MMO Reference: DCO/2022/00003
Planning Inspectorate Reference: EN010136
Identification Number: 20048964

Planning Act 2008, BP Alternative Energy Investments Ltd, Proposed Morgan Offshore Windfarm Generation Assets Order

Deadline 2 Submission

Figure 1: Plot showing the relationship between distance and received SEL for the north transect, for the maximum piling energy of 4,400 kJ.

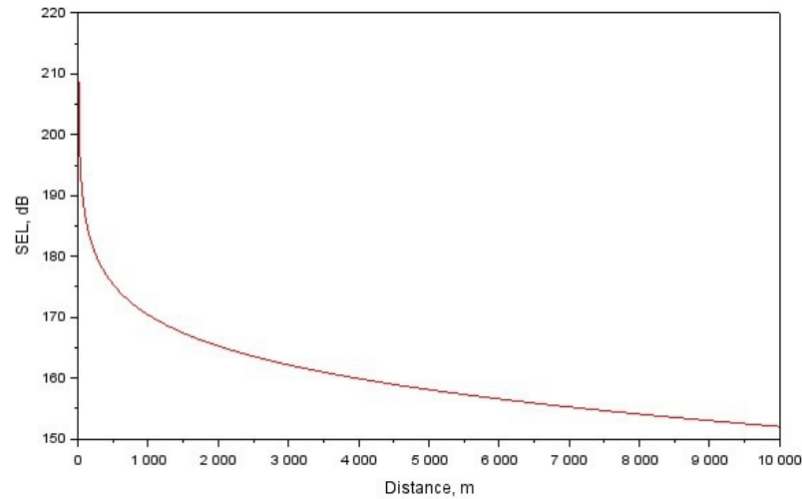
RR-020.79	As previously requested at PEIR stage, the MMO requests that a received level versus range curve/plot for a given transect be provided in Volume 3, Annex 3.1.	Please see below Figure 1 showing the received SEL against distance from the source.	The MMO thanks the applicant for providing clarification on this matter and has no further comments to add at this time.
